PLANNING COMMISSION  
MEETING AGENDA  
MAY 09, 2023  
7:00 P.M.

**CHIP'S AUTO GLASS**  
**12190 SPRINGFIELD PIKE**  
**PLAN REVIEW APP #20230124**  
**23020106**  
**MAY 5, 2023**

**MAPLE KNOLL VILLAGE - COVENTRY PAVILION**  
**11100 SPRINGFIELD PIKE**  
**PLAN REVIEW APP #20230199**  
**23020107**  
**APRIL 27, 2023**

**Maple Knoll Coventry Pavilion  
600 Maple Trace  
Development Plan Modification  
Application# 2023-0199  
May 9, 2023**

39 SQ FT PROPOSED

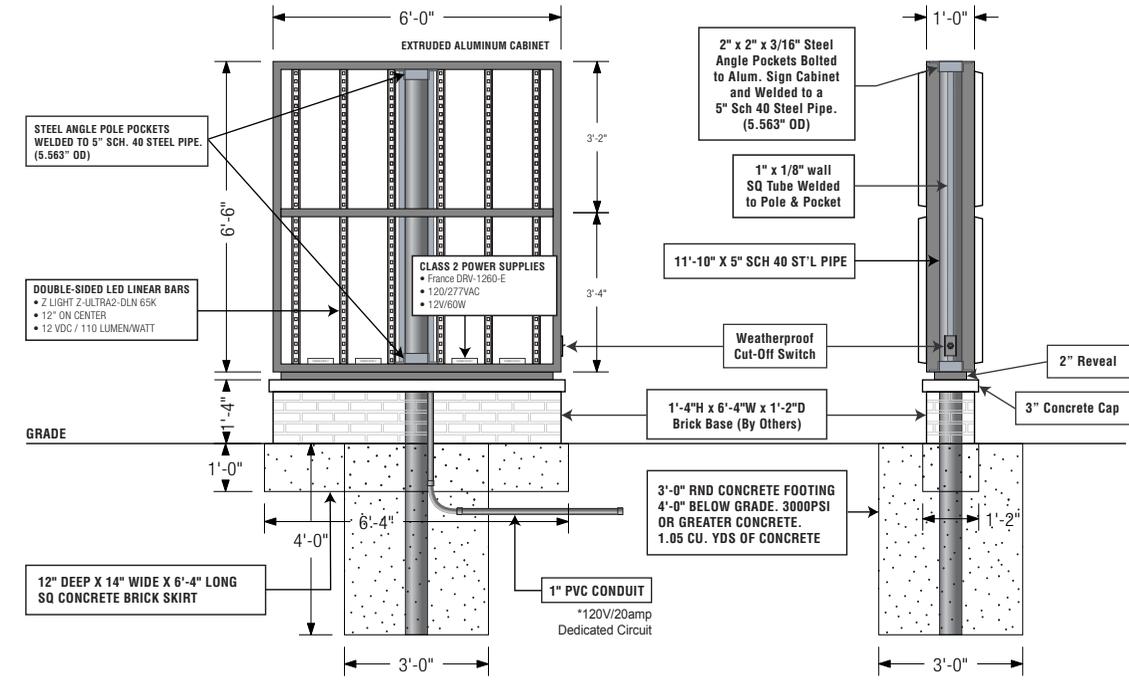
- 8) The applicant is proposing an 8 foot tall ground mounted sign on the Springfield Pike frontage. The sign would contain 39 square feet of which 20 square feet is a manual change copy sign. The sign would be mounted on a 1’ 6” brick base. The proposed sign is consistent with the requirements of the Zoning Code, provided it is located a minimum of 10 feet from the right-of-way and located in a landscape bed that is a minimum of 39 square feet. A site plan/landscape plan needs to be submitted for staff review and approval by staff.

- 1) A Landscape Plan be prepared for the Springfield Pike and Crescentville Road frontages and the base of the ground mounted sign to comply with the requirements of Sections 153.404 (F) and (G), and Section 153.459 (C) (3) (g). The landscape material is to be planted within 30 days of approval of the Landscape Plan by Staff.

**GRADING AND STORM SITE PLAN**  
 SCALE: 1" = 0' = 10'-0"

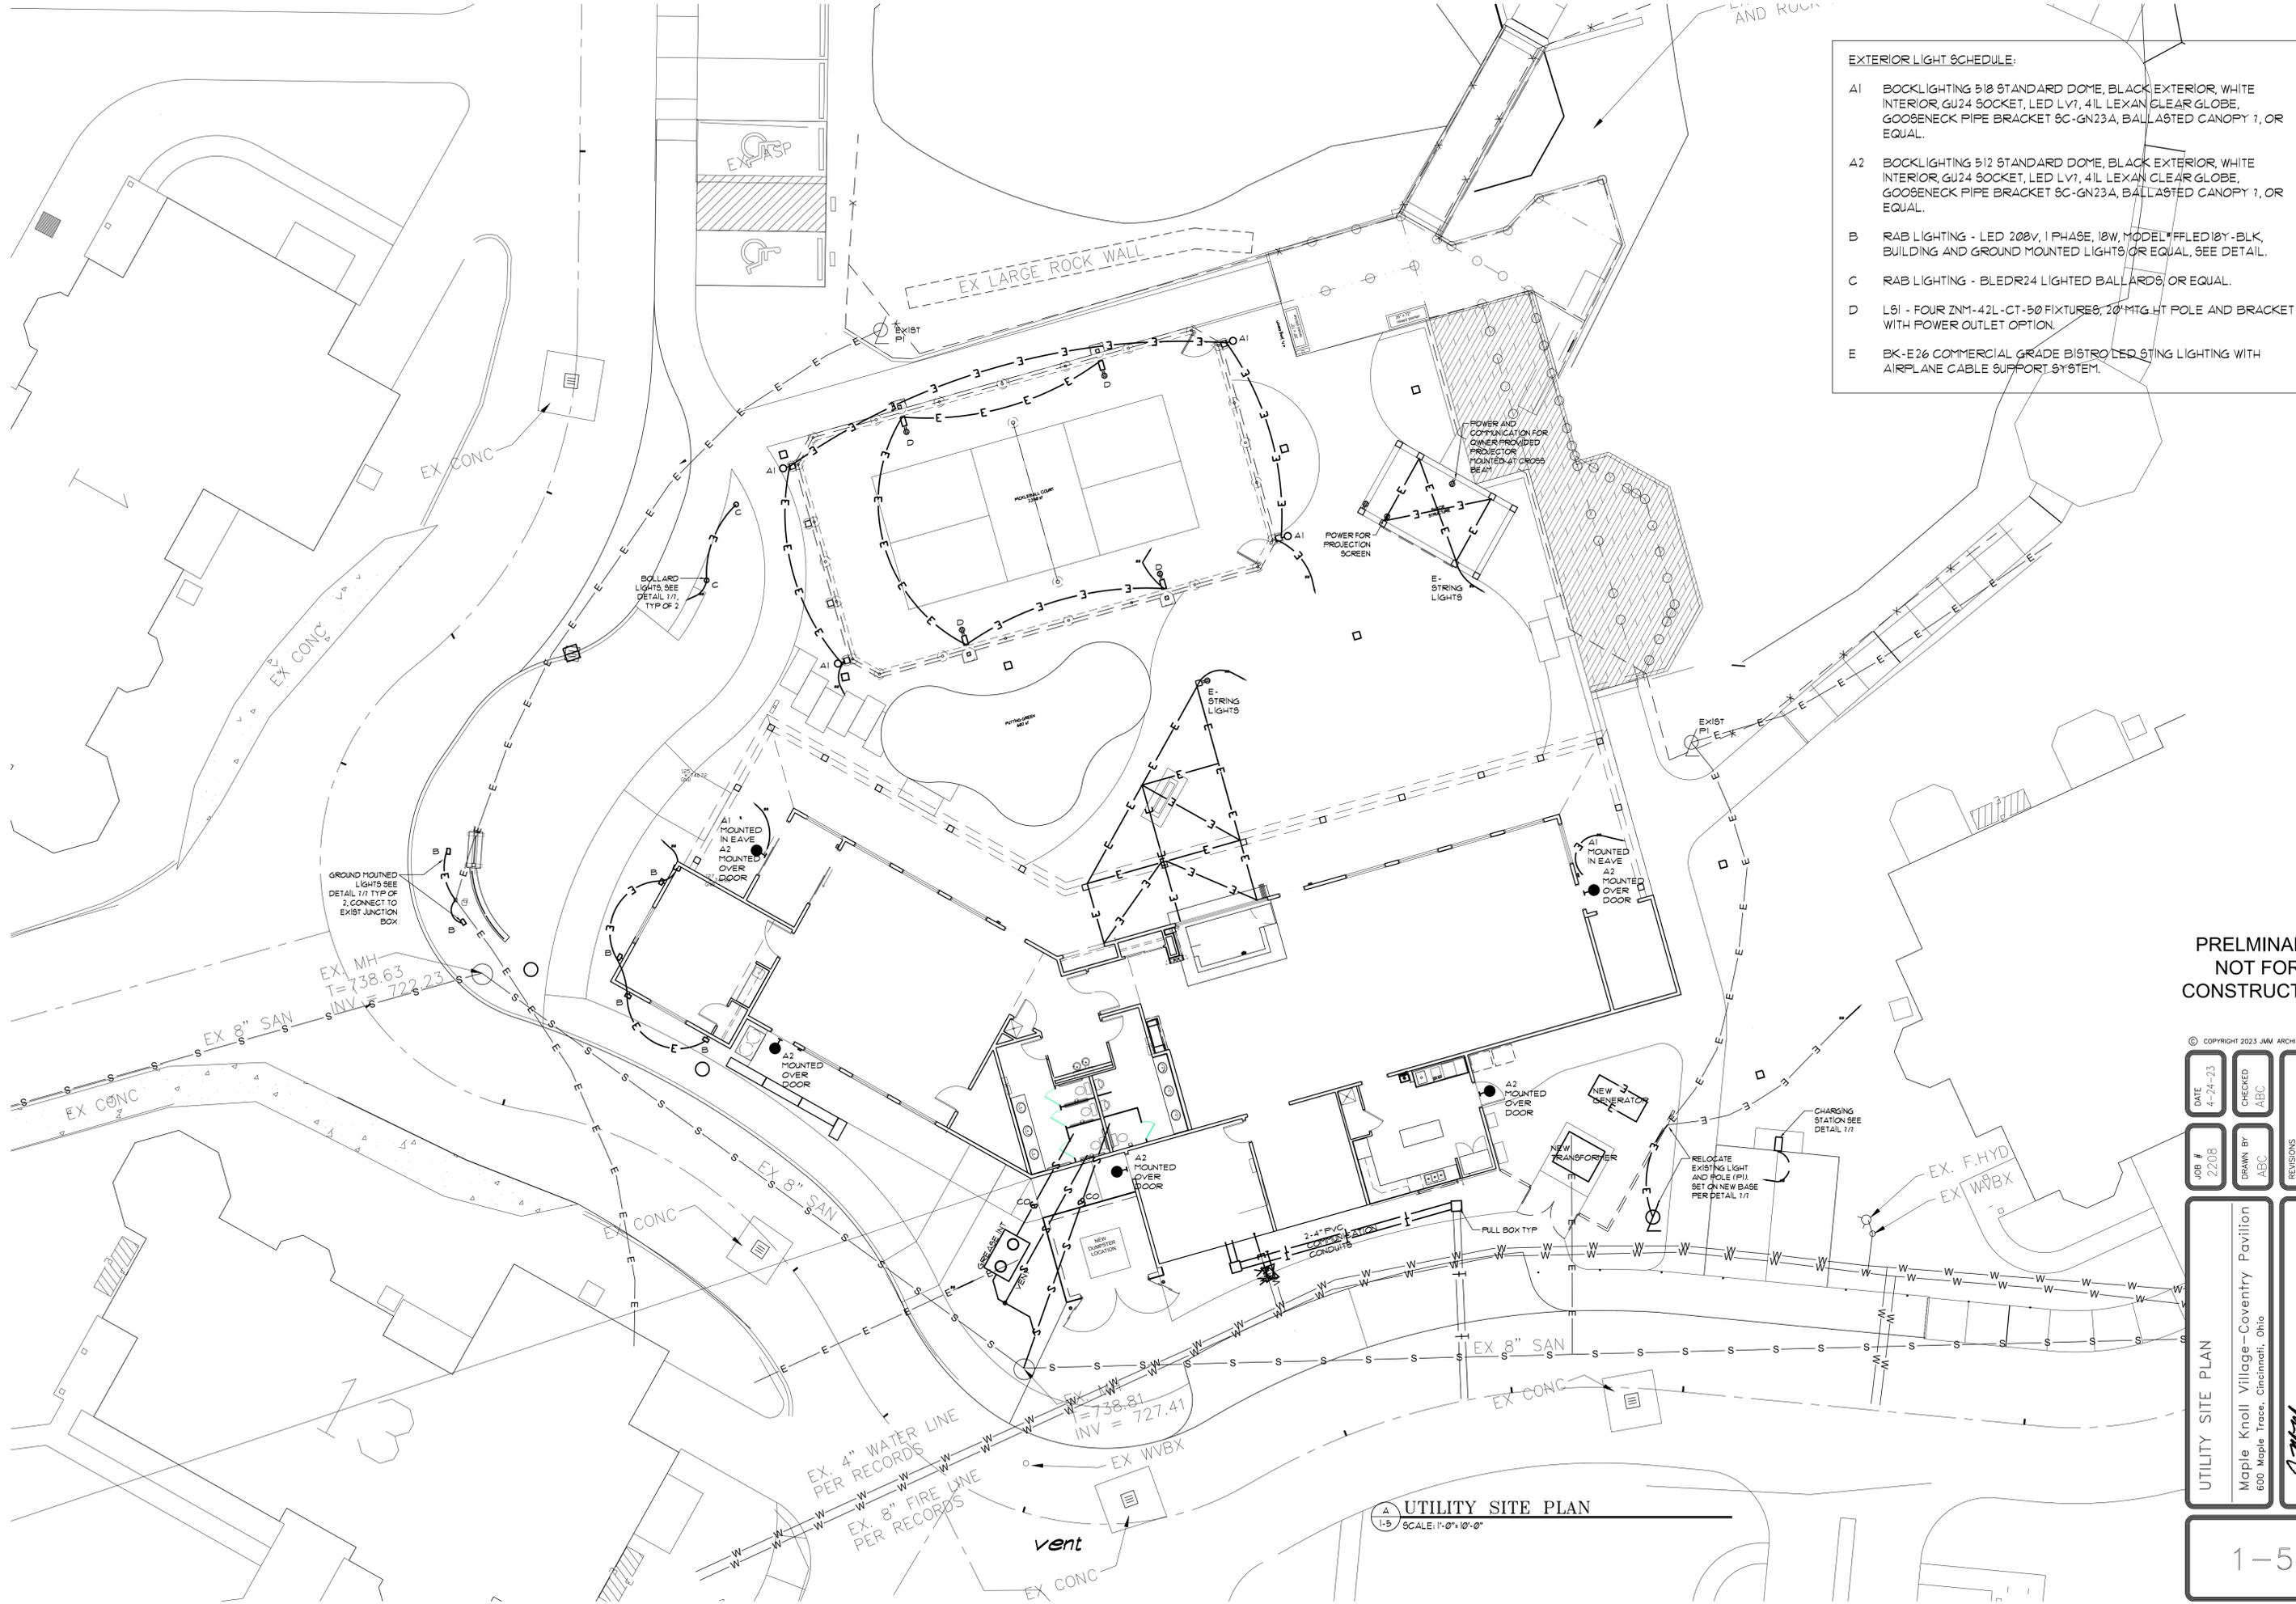
- B) The existing trees to remain need to be included in the Grading and Storm Site Plan (Sheet 1-4) and the Topographic Survey.
  - C) The size of the proposed trees need to meet the caliper inch size and not the identified height for single stem trees, per Section 153.403 (D) (2) (i).
